Consists of detailed information on the steam generator and reactor coolant pump support materials and evaluation of the fracture toughness and potential for lamellar tearing of the support materials...w/att mill certifications and support drawings

Donald C. Cook Nuclear Plant Unit Nos. 1 & 2
Docket Nos. 50-315 & 50-316
DPR No. 58 and CPPR No. 61

Mr. Don K. Davis, Acting Chief of Operating Reactors Branch #2, in his September 14, 1977 letter to us, requested that we supply detailed information on the steam generator and reactor coolant pump support materials and our own evaluation of the fracture toughness and potential for lamellar tearing of the support materials. Attachment I is our response to the above request. Specifications for detailing, fabrication and delivery of equipment supports are given in Attachment II. Attachment III and Attachment IV present mill certifications and support drawings respectively.

Figure 1 Steam Generator Lower Support Model

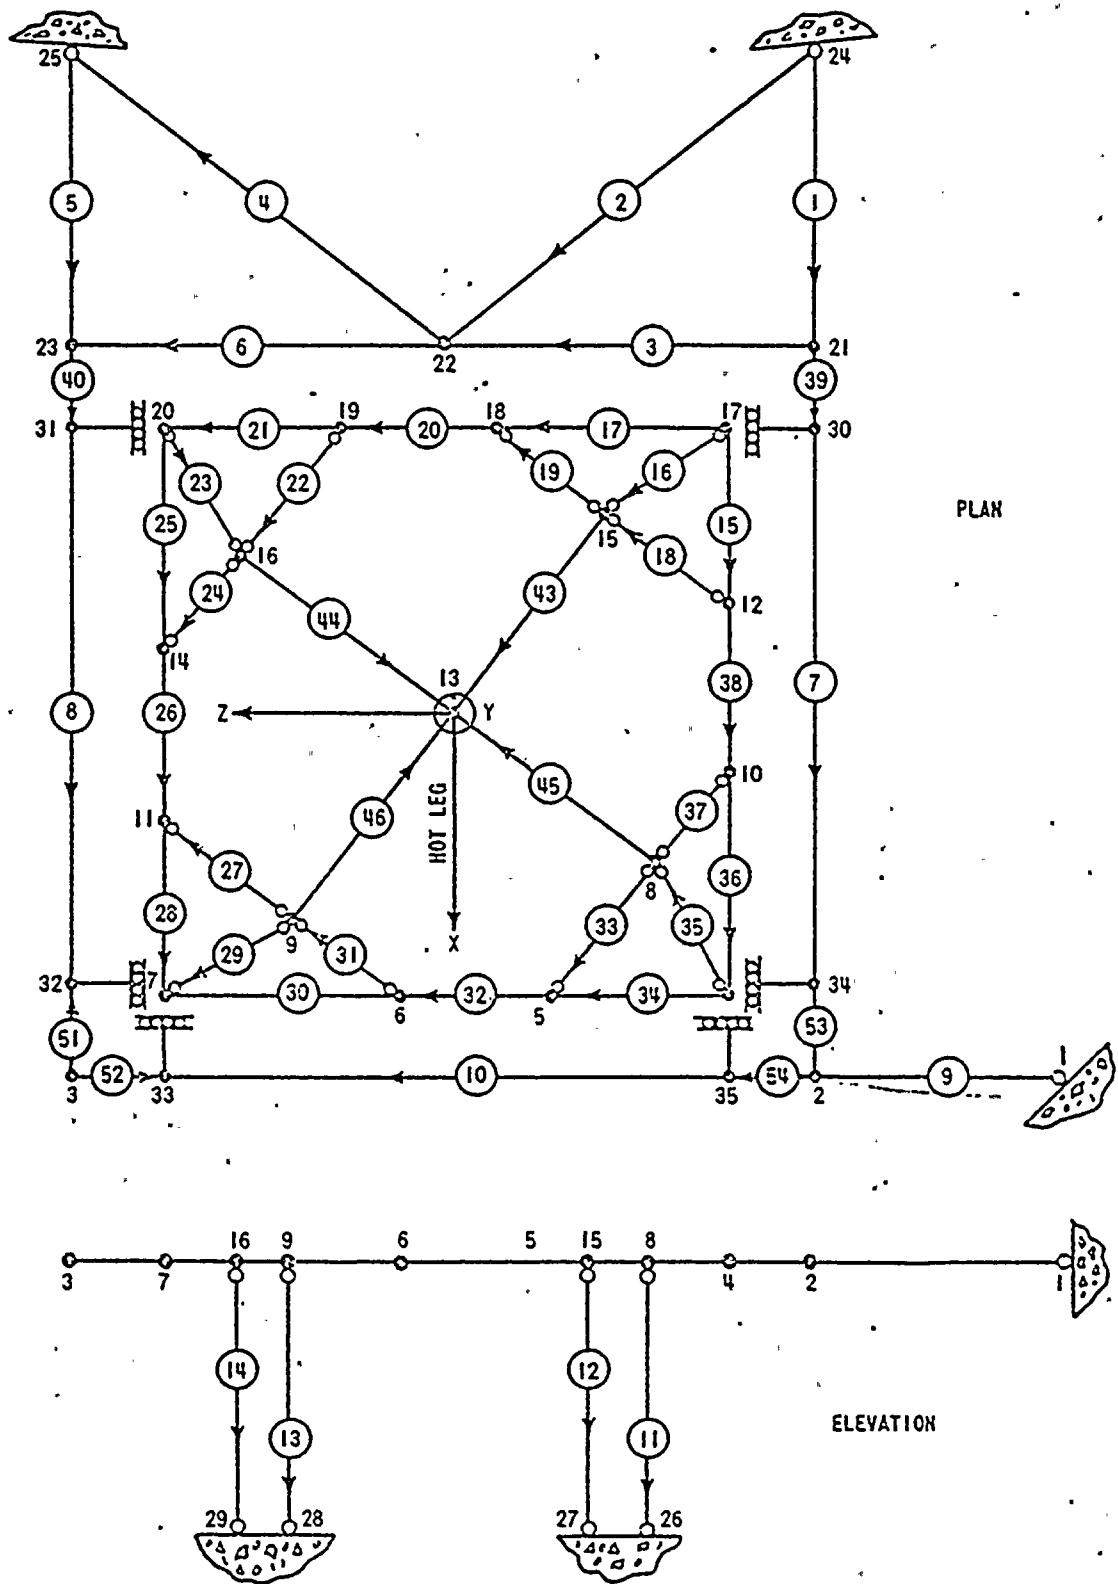
Specify the detailed design loads used in the analysis and design of the supports. For each loading condition (normal, upset, emergency and faulted), provide the calculated maximum stress in each principal elements of the support system and the corresponding allowable stresses.

The detailed design loads as provided by Westinghouse for the steam generator in report SD104 are given in the first 13 tables. Member stress levels expressed as a percentage of the allowable stress for the upper and lower supports are provided in tables 14 and 15. Figures 1 and 2 are provided to identify the elements of the steam generator supports. The loads for the Reactor Coolant pump supports are provided in tables 16 through 26. Tables 18 through 26 include both the loads and the margin of safety under the faulted condition for the R.C. Pump supports. Figure 3 is provided to identify the members. Stress levels for the R.C. Pump supports for the load cases normal, upset and emergency are provided in Table 27. Figure 3 identifies the elements for Table 27. The allowable stresses for each load condition and a description of the loading conditions themselves are provided in the following paragraphs.

In all cases the faulted condition controls the design. The maximum stress level found for the faulted condition for the steam generator lower lateral support was 84% of the maximum

+Member	Normal	Loading Upset	Condition Emergency	Faulted
1	-	3.2	3.7	34.2
2	-	5.3	5.9	14.8
3	-	7.7	8.9	30.7
4	-	4.6	5.1	13.6
5	-	3.4	3.8	36.4
6	-	12.1	13.4	35.8
7	-	3.5	3.8	49.6
8	-	3.4	3.7	53.8
9	-	11.8	13.0	4.5
10	-	8.7	9.9	64.9
11	51.4	57.9	40.0	68.1
12	9.4	19.5	16.1	65.9
13	38.2	43.7	30.1	68.4
14	2.3	7.7	6.8	69.7
15	-	3.3	3.5	24.6
16	-	5.3	6.1	22.3
17	-	13.4	14.7	43.3
18	-	.6	.6	6.2
19	-	3.3	3.6	15.5
20	-	7.6	8.4	22.9
21	-	23.3	25.7	84.0
22	-	2.9	3.2	13.3
